Oil Weep – Rear Face of Cylinder Heads**MODEL**1997 MY-ON XK8 Range
1998 MY-ON V8 XJ Series**VIN**001001-ON
812256-ON**Issue:**

ILLUSTRATION 1

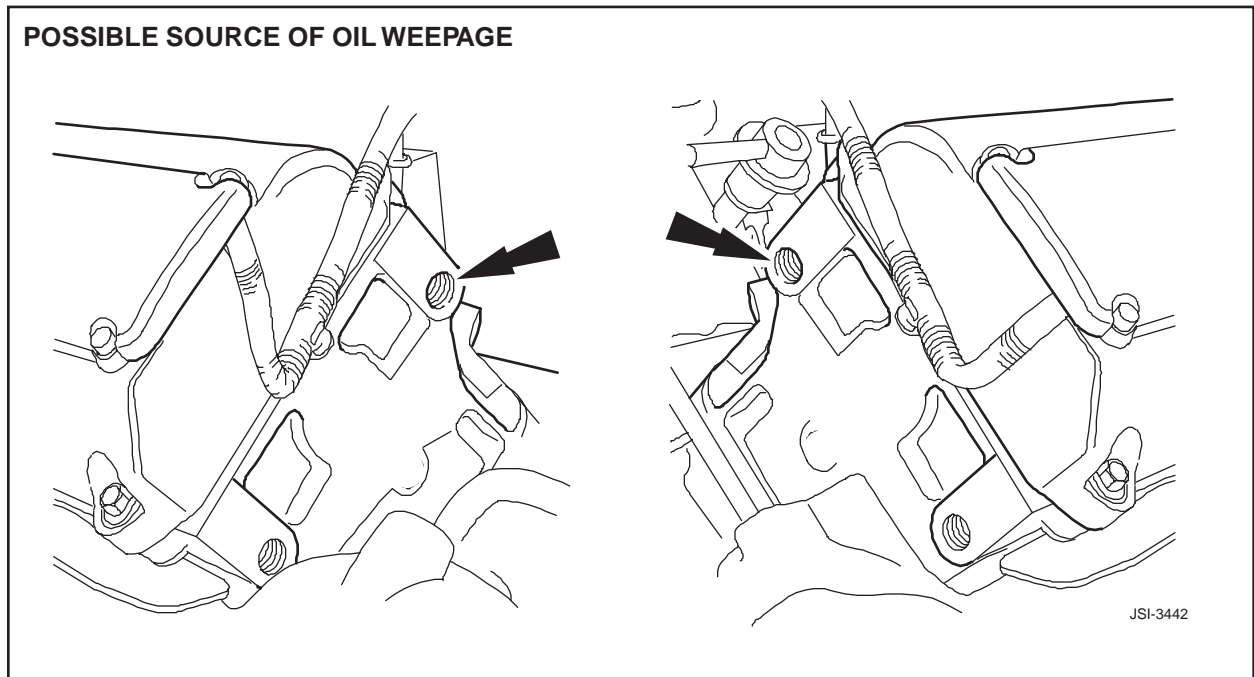
Some vehicles equipped with the AJ-V8 engine may experience oil weeps on the rear faces of cylinder heads. The cause may be oil weeping past a plug which is expanded, during engine manufacture, inside the inner (ie. the hole closest to the center-line of the engine) of the two threaded holes on the back of each cylinder head. These holes (Illustration 1) are also used to install the rear engine lifting brackets.

In case of a customer complaint of oil weepage that is found to come from the rear of the cylinder head, install a “Dowty” oil-sealing washer and bolt in the inner hole as described below. Clean the rear face of the cylinder head before installing the bolt and washer.

Torque: 15 Nm (11 lb ft)
